Technical Service Bulletin

42 Rear shock mounting noises

42 15 26 2042645/1 December 4, 2015.

Figure 1. Rear shock absorber assembly showing rear shock mount (point 4).

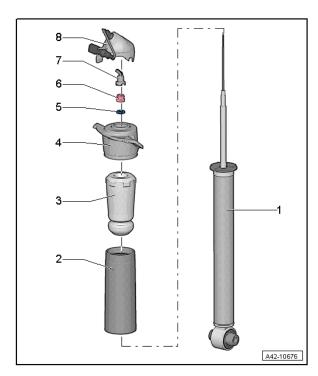
- Customer may report hearing rumbling noises from the rear of the vehicle when driving on very uneven roads or over potholes.
- This bulletin only applies to S3 vehicles with Audi magnetic ride.

The rear shock mounts are causing the noises (Figure 1).

- 1. Verify that the noise is coming from the rear shock mounts.
- 2. Remove both rear shock assemblies and replace both rear shock mounts according to Elsa instructions.
- 3. Test drive to verify repair.
